**Dublin San Ramon
Services District**

WWTP HVAC Replacements

CIP 22-P010

ADDENDUM NO. 2 TO CONTRACT DOCUMENTS

ARC FLASH WARNING LABEL

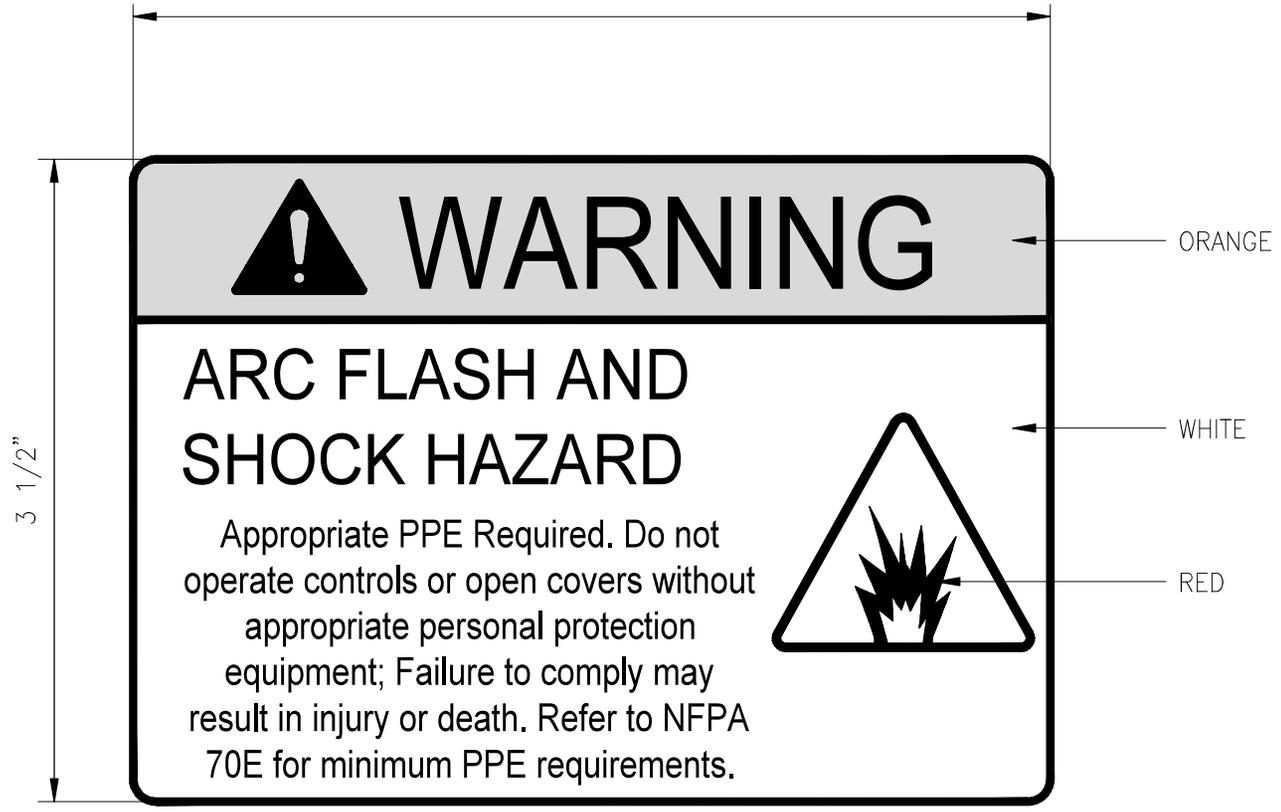
2) Q: Drawing E0.2a General Note 54 states to provide arc-flash hazard warning labels on affected electrical equipment. Compliance with NEC, NFPA 70E, IEEE 1584, and CEC 110.10 requires calculated incident energy levels. Please provide a specification section for power system studies.

A: The note in question does not require performing an Arc Flash Study. This is only asking for the Arc Flash Warning Label to be applied on all electrical equipment that is touched as part of this project. See attached Arc Flash Warning Label.
